CROSS SECTIONS

REVISED NDC02	STATE VA.	ROUTE 621	STATE PROJECT 6234-076-266, C-501, RW-201	SHEET NO. X178
------------------	--------------	--------------	--	-------------------

Ramp 1A

REVISED NDC02	STATE	STATE	PROJECT 6234-076-266, C-501, RW-201	SHEET NO. X183
	VA.	621

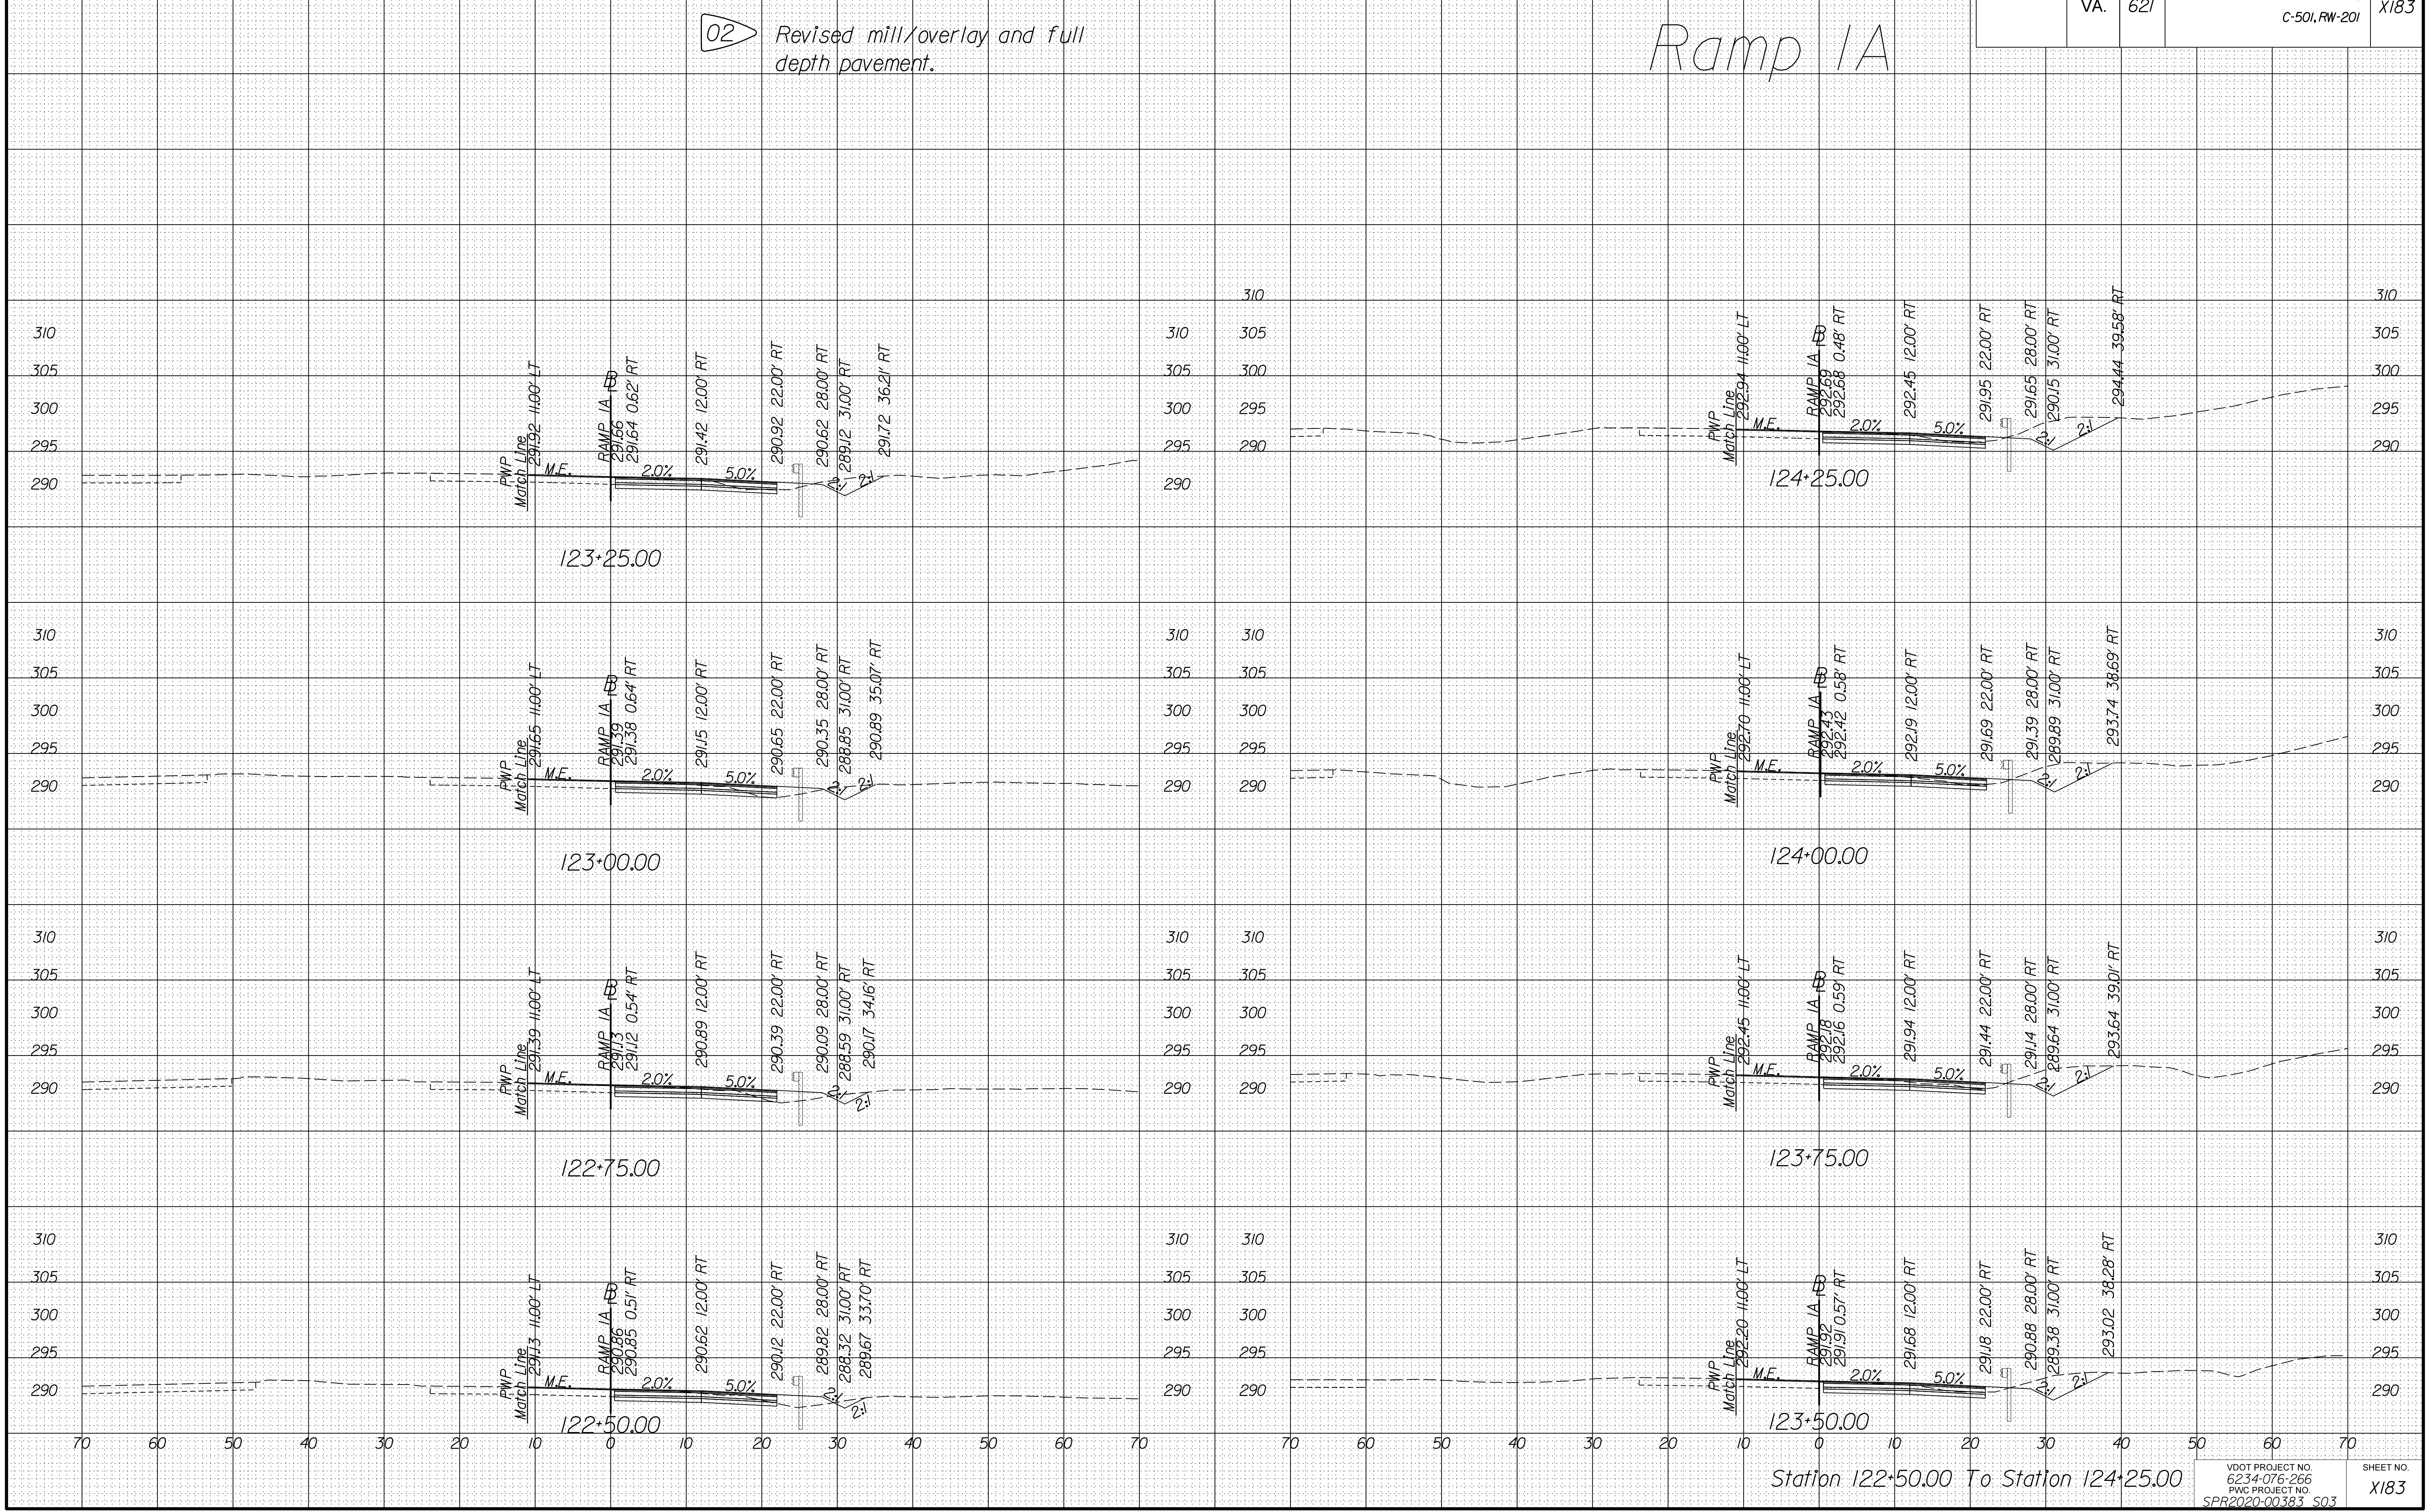
02 Revised mill/overlay and full depth pavement.

REVISED NDC02	STATE	STATE	PROJECT 6234-076-266, C-501, RW-201	SHEET NO. X184
	VA.	621

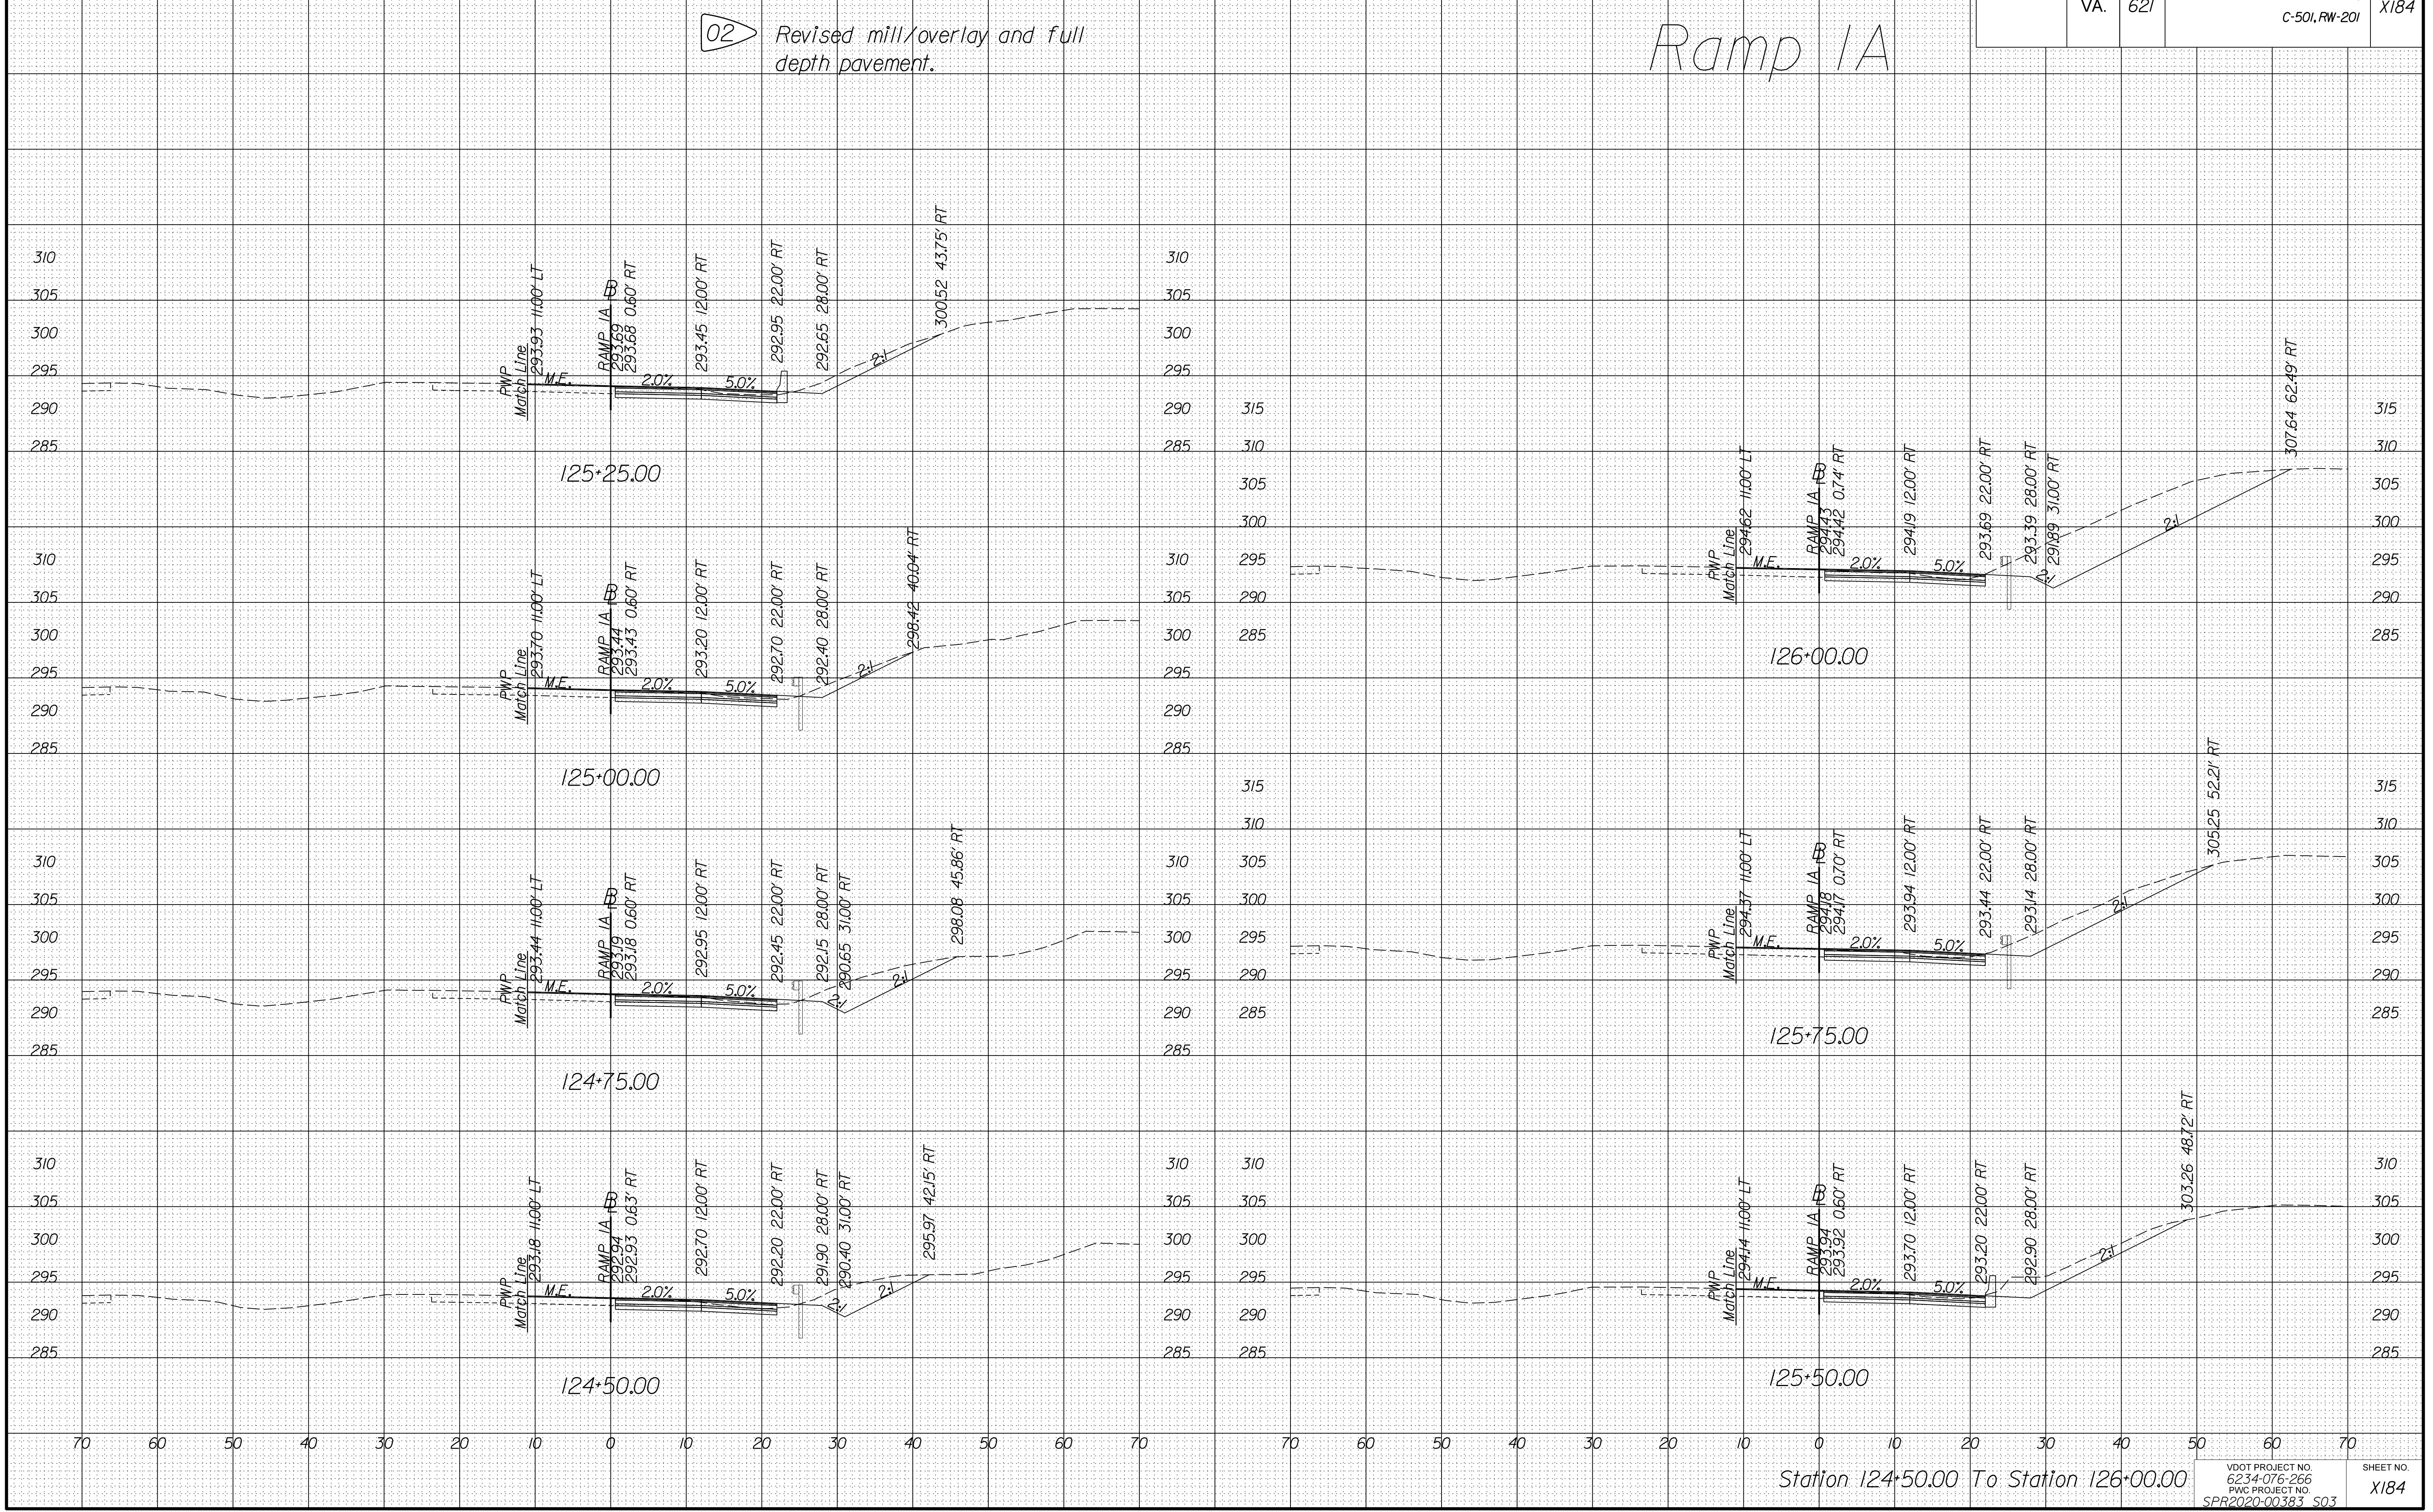
02 Revised mill/overlay and full depth pavement.

REVISION NDC02	STATE VA.	ROUTE 621	STATE PROJECT 6234-076-266, C-501, RW-201	SHEET NO. X185
-------------------	--------------	--------------	--	-------------------

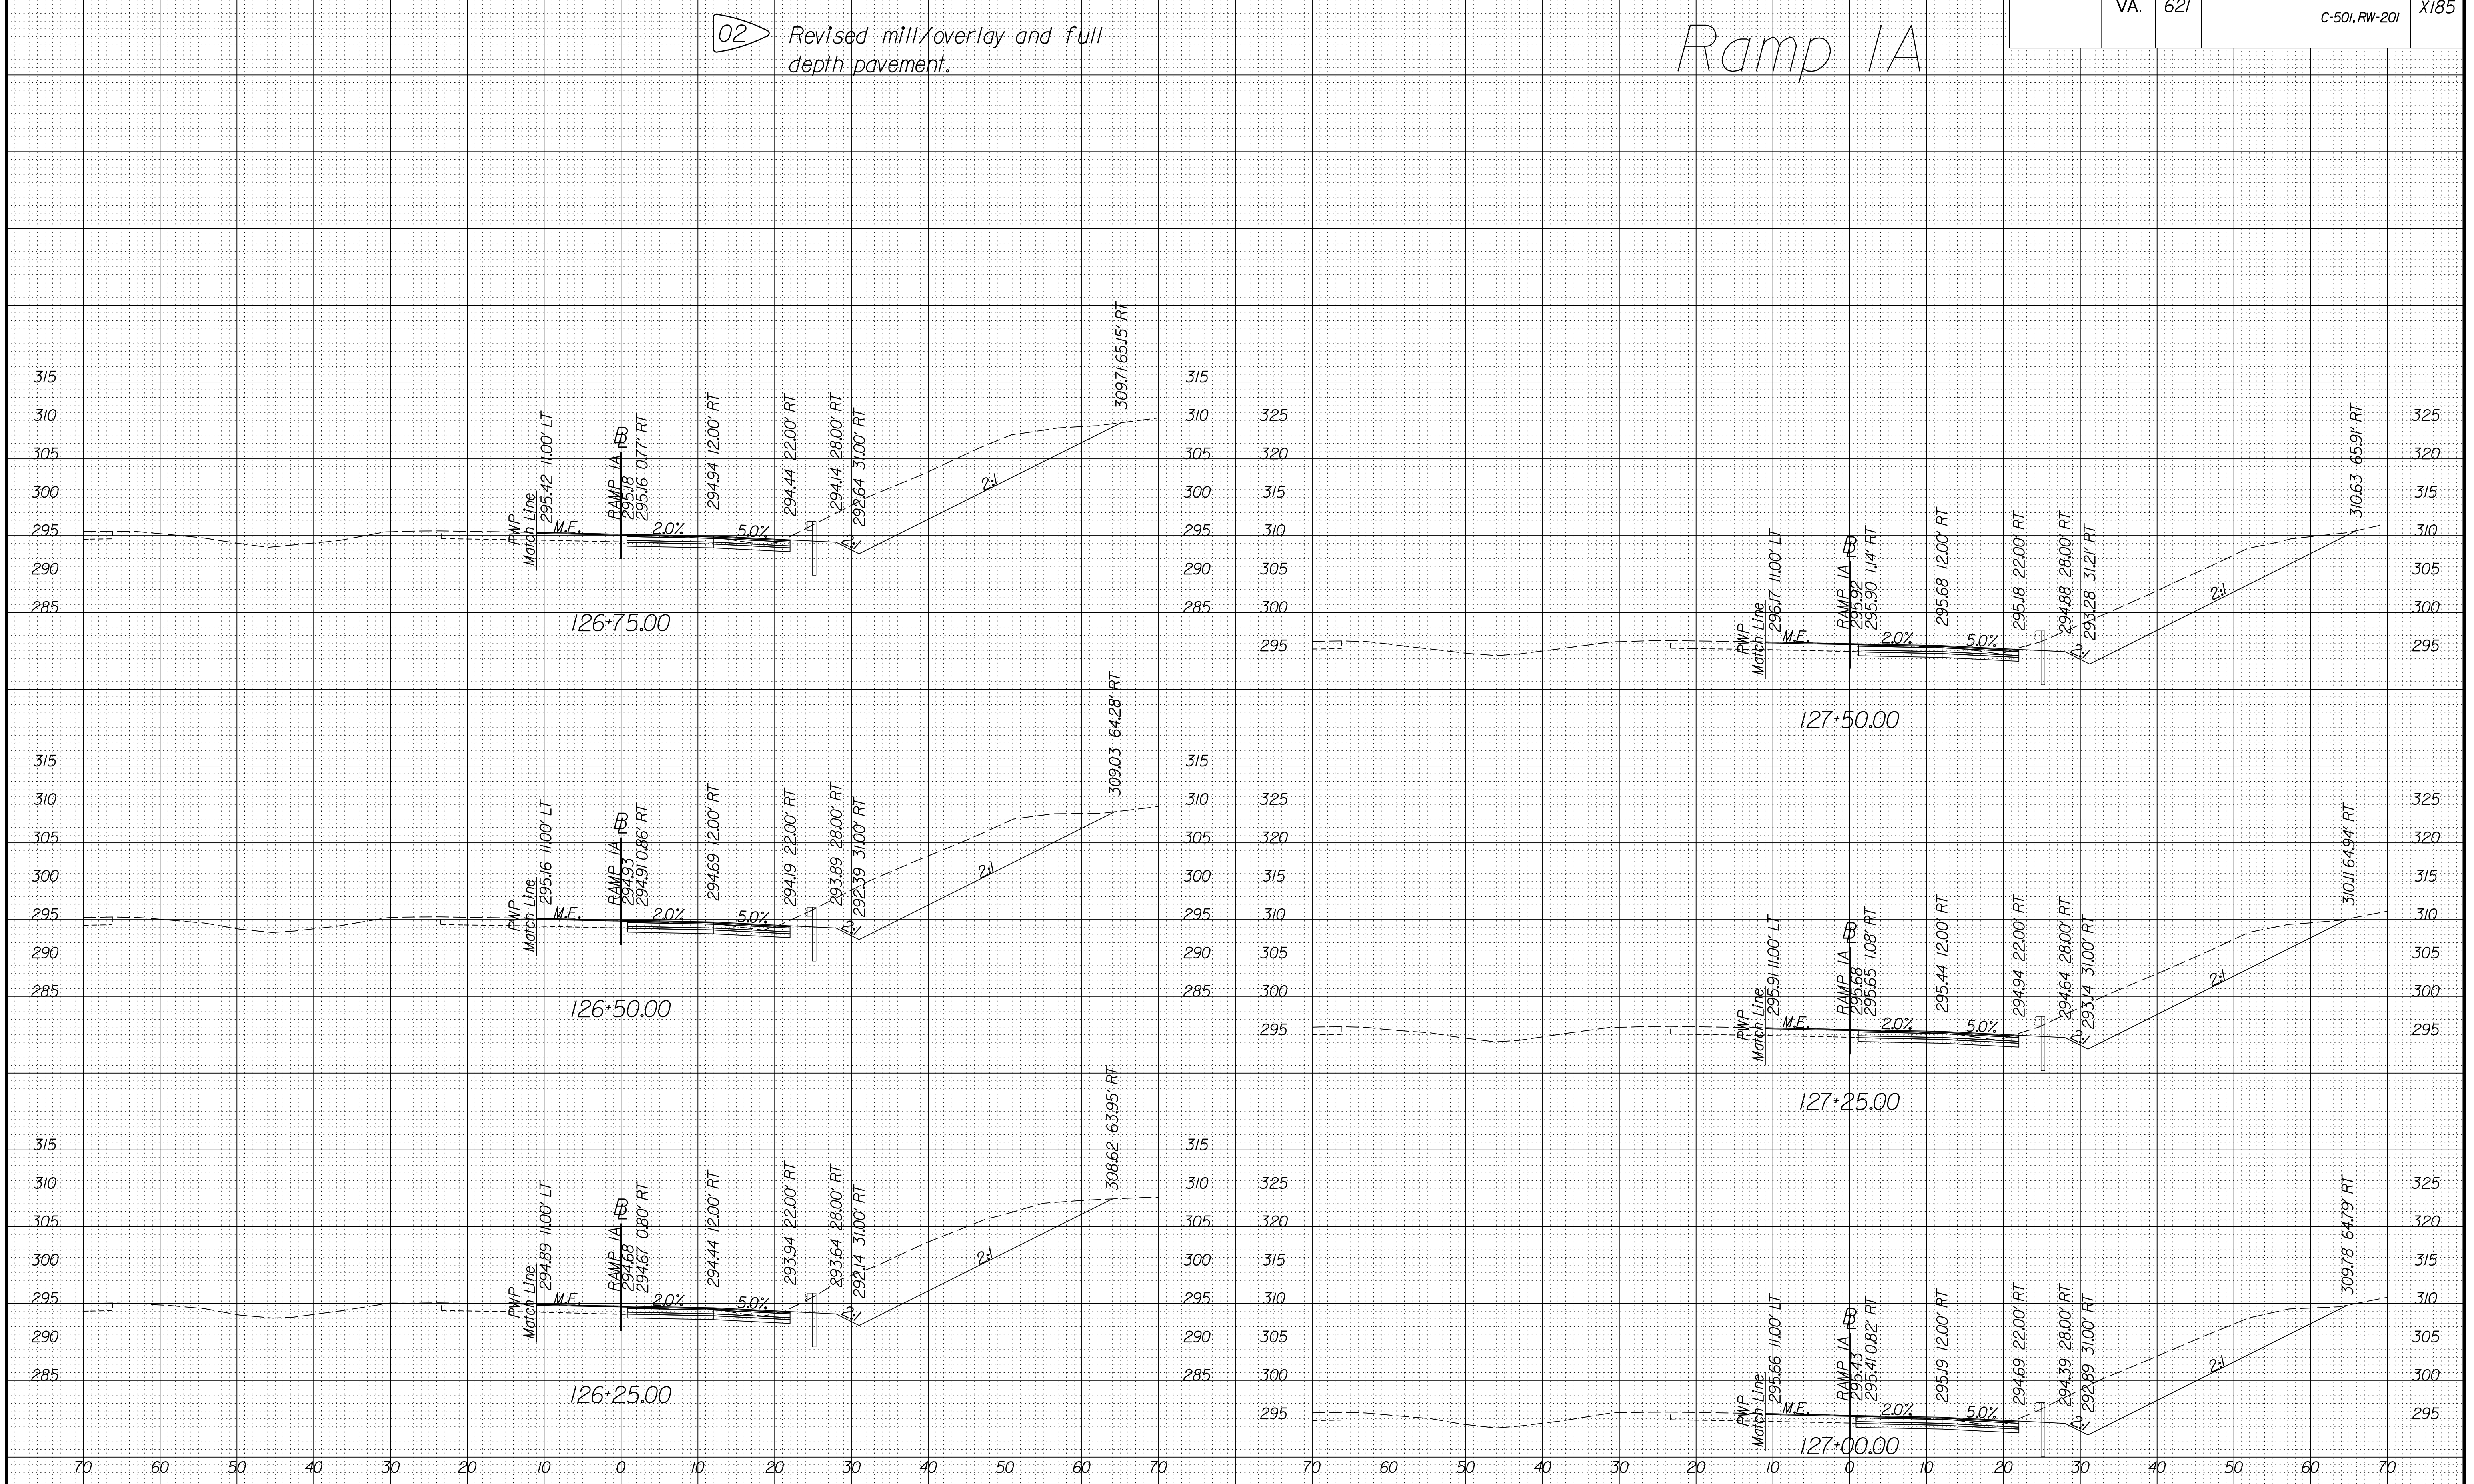
02 Revised mill/overlay and full depth pavement.
